PLANNING & DEVELOPMENT
CITY OF NEWARK

The City of Newark's Subdivision Advisory Committee has reviewed the major subdivision plan for the proposed Hilton hotel at 1119 South College Avenue (PR#22-01-01). We have the following comments:

Electric Department Attachment

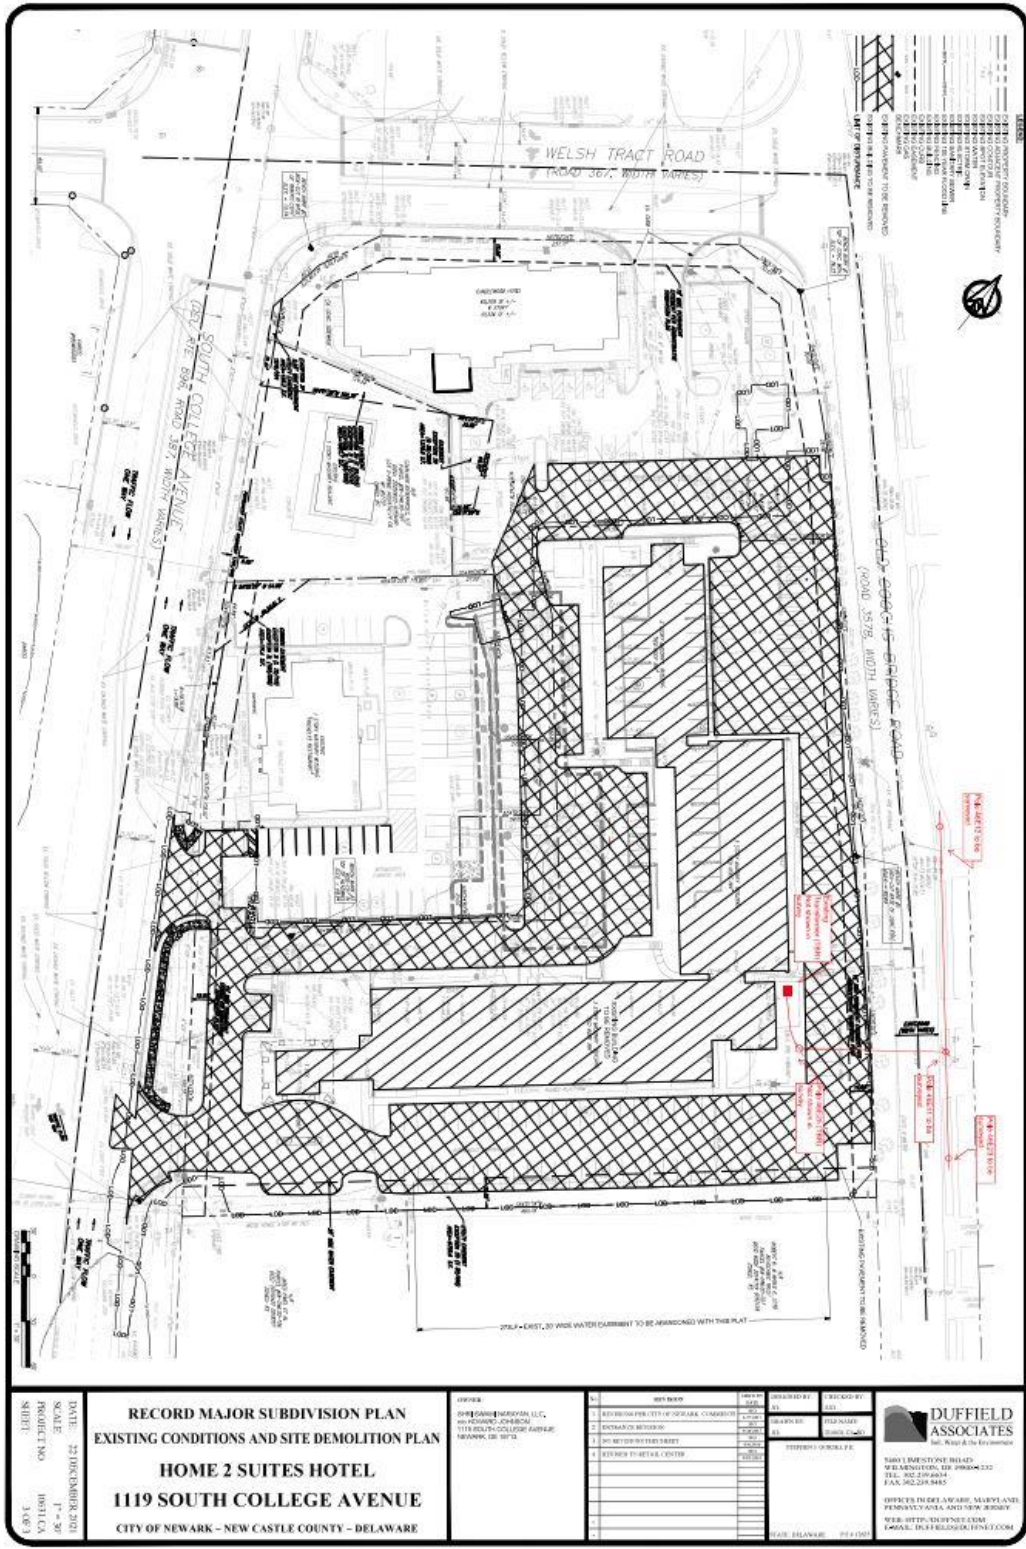
1. Electric service is available from Old Cooch's Bridge Road pole # 46E25.
2. An open utility easement is required and must be listed on the prints.
3. All overhead and underground electric must be surveyed and shown on the print, including utility poles. The developer must survey the poles on Old Cooch's Bridge so we can determine the best pole to feed from. See our comments attached.
4. Parking lot lights must be shown on prints to ensure they are not too close to the power line.
5. The proposed pad-mounted transformer location must be shown on print.

6. The developer must install 2-4" SCH. 40 PVC conduits from the transformer to the future commercial pad site.
7. A suitable location approved by the Electric Department will be required for a pad-mounted transformer for future commercial pad site.

8. Any oil-filled pad-mounted equipment shall be located a minimum of 10' from combustible buildings, windows, doors, and stairwells
9. Someone must contact the Electric Department with information on the transformer location and electric service needs before any costs can be calculated.
